Re: Railway (Metrolink - Estuary to Charlemont via Dublin Airport) Order [2022]
Metrolink. Estuary through Swords, Dublin Airport, Ballymun, Glasnevin and City Centre to
Charlemont, Co. Dublin

Re: Railway (Metrolink-Estuary to Charlemont via Dublin Airport) Order 2022

MetroLink Submission

Dartmouth Square West Submission

Figure 22: Permanent Acquisition of Lane (outlined in red)

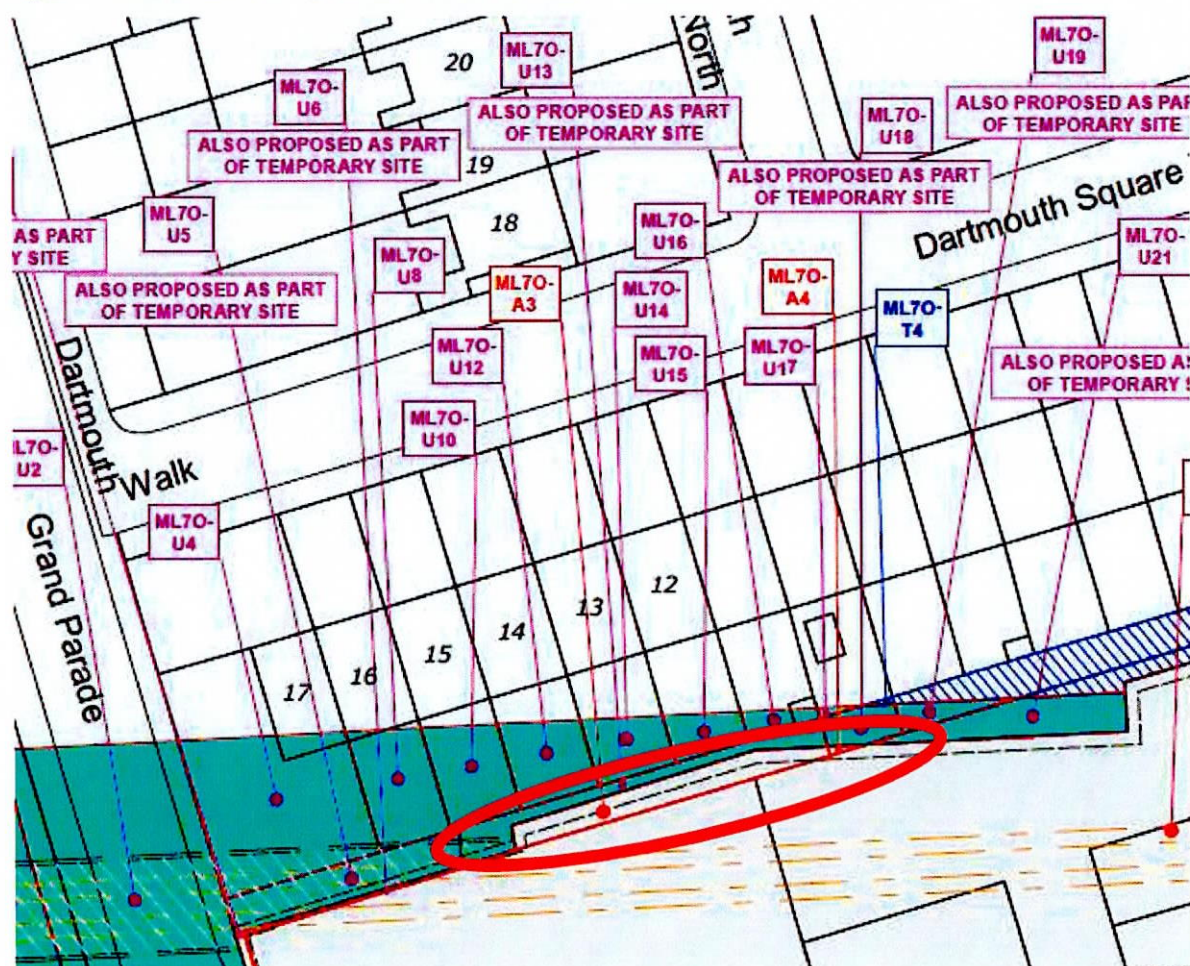
Under the proposed railway works of Dartmouth Square, the plans demarcate proposed permanent acquisition (ML 70-A3). The Metrolink proposal includes permanently acquiring a significant portion of the laneway from no. 11 to 15 inclusive with approximately 30% of the laneway width remaining at this location. This leaves c.800mm of space between the proposed permanent acquisition site area and the garden walls to properties no. 11-15 inclusive. In addition, the remainder of the laneway is due to be a temporary site.

The Application as proposed is in breach of the agreement. In the circumstances, it is submitted that TII ought to amend the application to ensure it complies with their obligations under this agreement.
